## All Products that Utilize a Drive Coupler Disk Assembly

**Date:** October 30, 2006

### **Subject: Correct Drive Coupler Assembly Installation and Orientation**

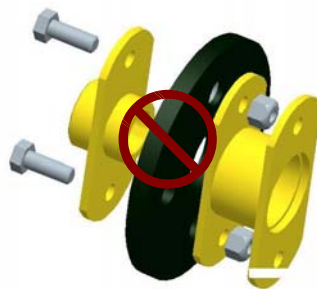
During repair of a Toro Product with any Drive Coupler Assembly, the installation orientation of the assembly should be verified for proper installation of coupler and hub; the proper orientation for the Drive Coupler Assembly is at ninety degrees apart.

Incorrect Drive Coupler Installation shown on top picture: The Drive and Driven Coupler are incorrectly installed in-line.

Correct Drive Coupler Installation on the picture below: The Drive and Driven Coupler are installed ninety degrees apart from one another.
